UNITED STATES PATENT AND TRADEMARK OFFICE

10/815,149

Office Action Summary	Application No. 10/815,149	Applicant(s) VANDENBROEK ET AL.	
	Examiner THOMAS MCEVOY	Art Unit 3731

DETAILED ACTION

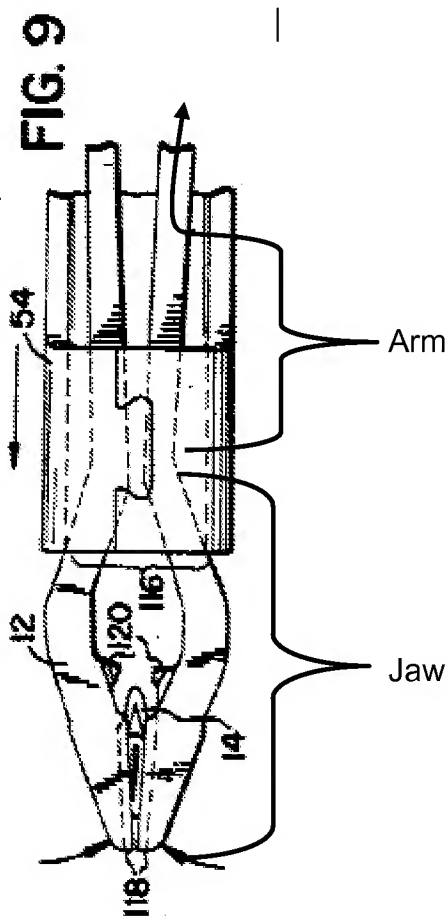
Regarding claim 10, Yawata et al. disclose a jaw assembly adapted for use with a handle assembly in a surgical clip applier, comprising: a pair of jaws, 134a and 134b, adapted to receive a surgical clip, the jaws are movable between an open state and a closed state (p. 11, lines 5-6); a pair of elongate support arms, 132a and 132b, each adapted to support an associated one of the jaws between the open state of the jaws and the closed state of the jaws; a bridge 130 (Figure 10) disposed between the support arms to hold the jaws in an aligned relationship between the open state and the closed state; a housing, 101 and 102, disposed over at least the bridge, the housing having a

generally fixed relationship with the bridge while permitting movement of the jaws between the open state and the closed state; and a coupling (bottom surface of 101 which contacts scissors) included in the housing, the coupling being adapted for attaching the housing to the handle assembly. Regarding claim 11, the jaw, support arms and bridge contact each other and are integral. Regarding claim 12, the claimed phrase "wherein the housing the molded over the bridge" is being treated as a product by process limitation; that is, as set forth in MPEP 2113, product by process claims are not limited to the manipulation of the recited steps, only the structure implied by the steps. Once a product appearing to be substantially the same or similar is found, a 35 USC 102/103 rejection may be made and the burden is shifted to applicant to show an unobvious difference. MPEP 2113. The housing, 101 and 102, is found to be substantially the same or similar to the claimed housing. Regarding claims 13 and 14, the jaws are resilient and biased in the open position (p. 11, lines 5-6). Regarding claims 15-18, the jaws open and close in a plane separating the top and bottom surfaces of the arms. In a closed state, only the top and bottom surfaces of the arms can be in contact with the top and bottom sides of the housing (first and second portions) and the side surfaces can be squeezed out of contact with the side surfaces of the housing.
